Access Compliance Report

Public Rights-of-Way

(Pedestrian Signals)

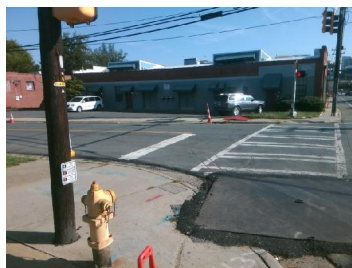
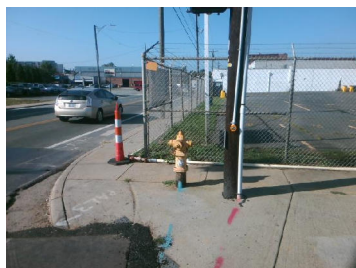
Yes	B 1 Clear Xing Direction?	ClearlyMarked	N/A	B 2 Clear Xing Direction?	N/A
	B 1 Crossing Direction	To SE		B 2 Crossing Direction	N/A
Yes	B 1 DistanceTo XWalk (in)	0.0	N/A	B 2 DistanceTo XWalk (in)	N/A
No	B 1 DistanceTo Curb (in)	108.0	N/A	B 2 DistanceTo Curb (in)	N/A
Yes	B 1 Diameter (in)	2.0	N/A	B 2 Diameter (in)	N/A

Possible Solutions: Replace Signal Push Button With APS Button on New Post. Remove & Relocate Sign.
